Access Compliance Report

Public Rights-of-Way

Intersection ID: 30550	Main Street: ARBORETUM SHOPPING CENTER DR	Side Street: PROVIDENCE RD	Location: NW
ADA ID: BA1211B86800	Ramp Type: PerpDiag	Initial Pass/Fail: Fail	Overall Compliance: No
Severity Score: 22.5			
Codes/Mitigation Info/Possible Solution		Field Measurements/Component Compliance

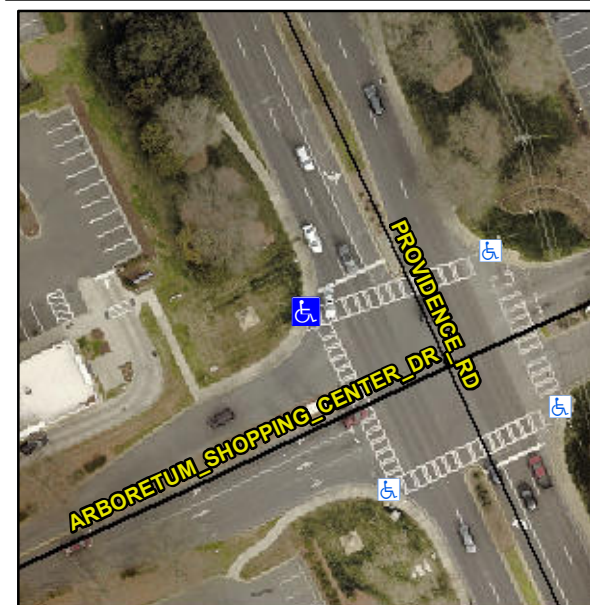
Not Found, R304.5.1, R304.2.2

Compliance	Description	Data	Compliance	Description	Data
N/A	Ramp Length (in)	60.0	No	Ramp Slope (%)	10.0
No	Ramp Width (in)	46.0	Yes	Ramp XSlope (%)	2.5
N/A	Flare Type LT	N/A	N/A	Flare Type RT	N/A
N/A	Flare Slope LT (%)	N/A	N/A	Flare Slope RT (%)	N/A
N/A	Flare Traversable LT?	N/A	N/A	Flare Traversable RT?	N/A
N/A	Landing Length (in)	N/A	N/A	DWS Provided?	N/A
N/A	Landing Width (in)	N/A	N/A	DWS Contrast?	N/A
N/A	Landing Slope (%)	N/A	N/A	DWS Length (in)	N/A
N/A	Landing X Slope (%)	N/A	N/A	DWS Full Width?	N/A
N/A	Landing Curb? (Y/N)	N/A	N/A	DWS Offset (in)	N/A
N/A	Shared Landing?	N/A			
N/A	Gutter Ponding?	N/A	N/A	Gutter Slope (%)	N/A
N/A	Gutter Lip Ht (in)	N/A	N/A	Gutter X Slope (%)	N/A
N/A	Painted X Walk1?	Yes	N/A	Painted X Walk2?	Yes
	X Walk 1 Direction	To SE		X Walk 2 Direction	To NE
N/A	X Walk 1 Width (in)	84.0	N/A	X Walk 2 Width (in)	107.0
	X Walk 1 Slope (%)	1.2		X Walk 2 Slope (%)	5.5
	X Walk 1 X Slope (%)	4.0		X Walk 2 X Slope (%)	1.8

Remove & Replace Curb Ramp With Two New Directional Ramps or Equivalent. Restripe Crosswalk.
